**Port Hills Geotechnical Group
Assessment of GNS Model Applicability for Cliff Collapse Risk**

Sector: 1 Address: 88 BULLOCK BAY

Port Hills Geotechnical Group
s124 (geo) Notice Decision Process - Cliff Collapse

Address of property: 1 BOULDER BAY

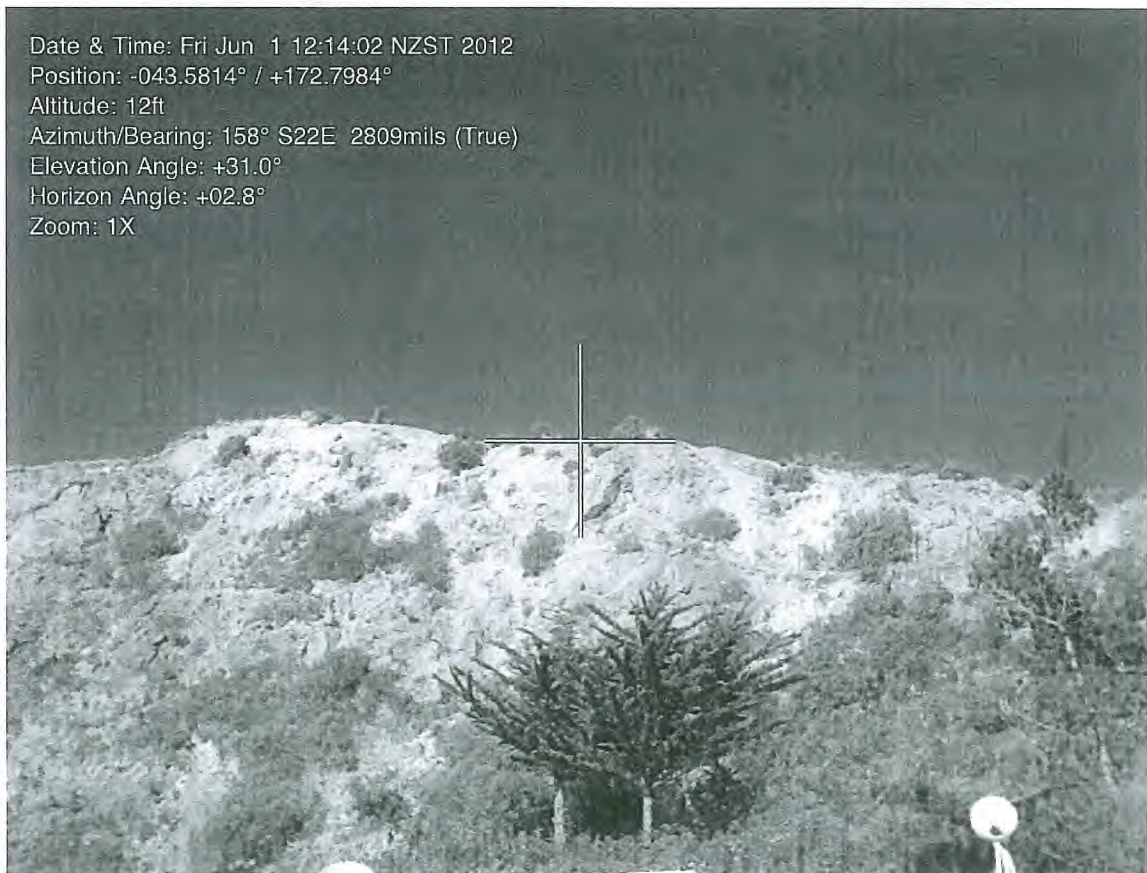
Comments:

Date & Time: Fri Jun 1 12:14:02 NZST 2012
Position: -043.5814° / +172.7984°
Altitude: 12ft
Azimuth/Bearing: 158° S22E 2809mils (True)
Elevation Angle: +31.0°
Horizon Angle: +02.8°
Zoom: 1X

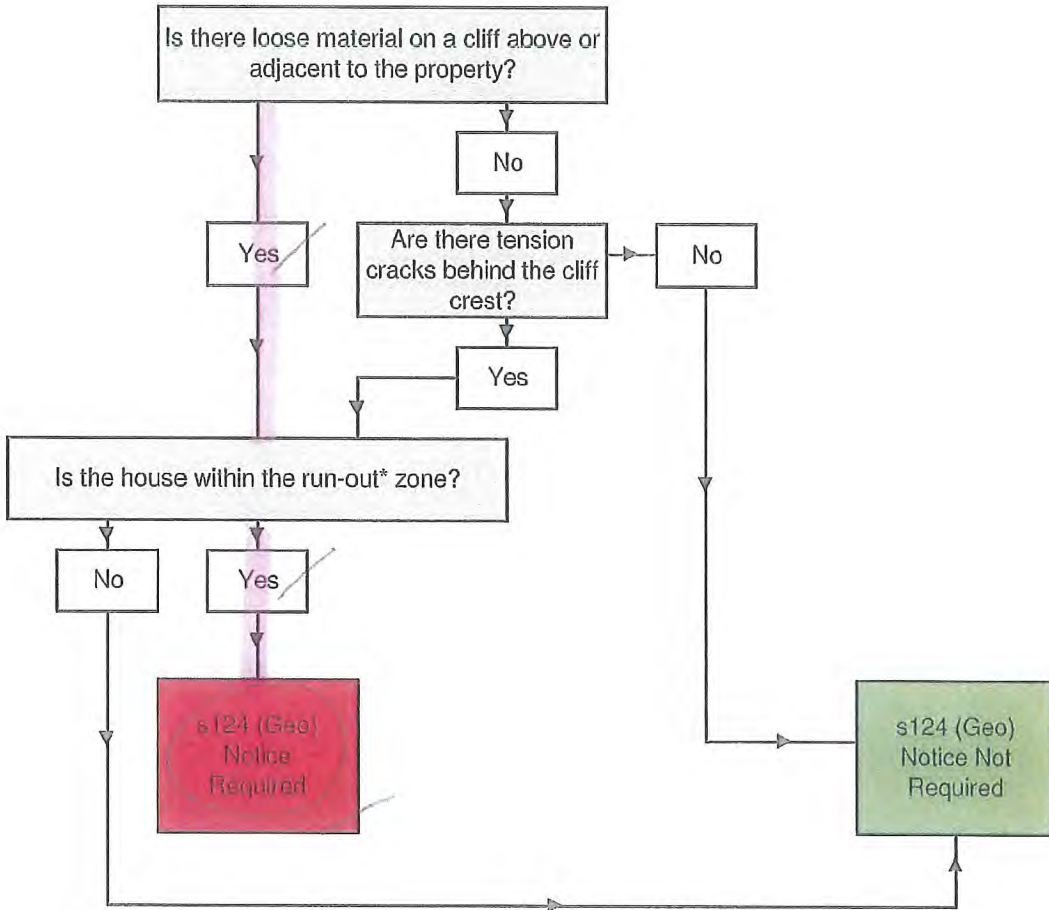
Comments: TENSION CRACKS IN SLOPE DIRECTLY ABOVE PROPERTY.

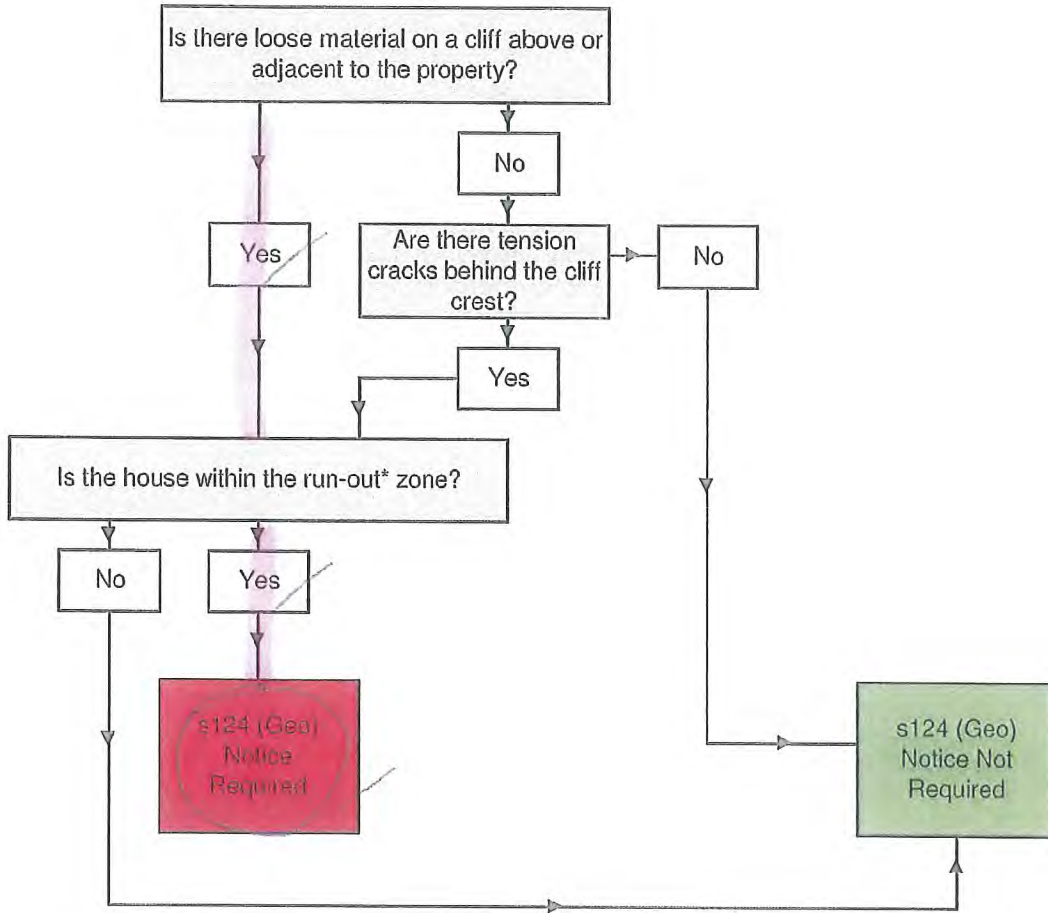
Comments:
S124 in place already

tension crack at cliff crest
